MECKLENBURG COUNTY HEALTH DEPARTMENT

APPLICATION FOR PERCOLATION TEST

SOIL INVESTIGATION REPORT

SITE INVESTIGATION REPORT
INDIVIDUAL SEPTIC TANK SYSTEM
WITH SUBSURFACE,
SOIL ABSORPTION,
EFFLUENT DISCHARGE

DIAGRAM OF PROPERTY

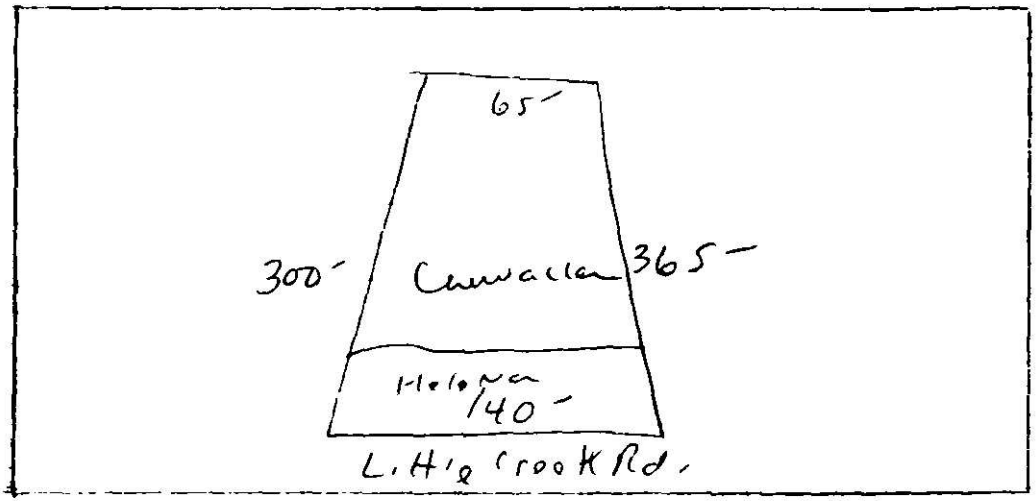
Soil Properties	Soil 1	Soil 2	Soil 3	Soil 4
1. Soil Series	Helena		Chewacla	
2. Soil Slope	Suitable 2-6%		—	
3. Soil Depth	unsuitable <48"		—	
4. Soil Texture	unsuitable 2:1 expanding clays		—	
5. Soil Structure	unsuitable massive		—	
6. Restrictive Horizons	—		—	
7. Soil Drainage	unsuitable perched high water table		unsuitable poorly drained	
8. Soil Permeability (Percolation Rate)	unsuitable very slow >200 min./in.		unsuitable seasonal high water table <18" from surface	
9. Other	—		unsuitable floods	
10. Overall Rating	unsuitable		unsuitable

Recommendations Based on this investigation, the lot was found to have soils dominantly unsuitable for installation of a septic tank system.

See diagram on back
